This errata is applicable to the following devices:

- AT89S8252
- AT89LS8252
- AT89S53
- AT89LS53

AT89S8252 AT89LS8252 AT89S53 AT89LS53 Errata Sheet

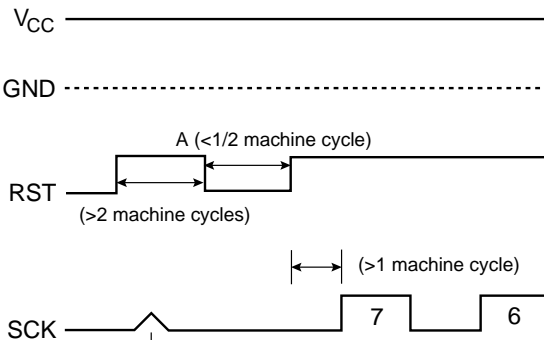
Regarding the in-system programming procedure, ATMEL currently recommends the following ISP waveforms for implementing the ISP programming algorithm in the AT89S-series devices:

(V_{CC} should be powered up and stable PRIOR to the waveforms below)

This glitch MAY occur in certain systems because when RST goes high, port 1 pins will be driven with a strong pullup for one clock cycle; if the glitch does occur, it can be interpreted incorrectly as the first SCK pulse of a serial data stream. So the falling edge of RST at point A is necessary to "clean-up" the internal state machine.

These waveforms should be used in addition to the serial downloading waveforms shown in the respective device datasheets.
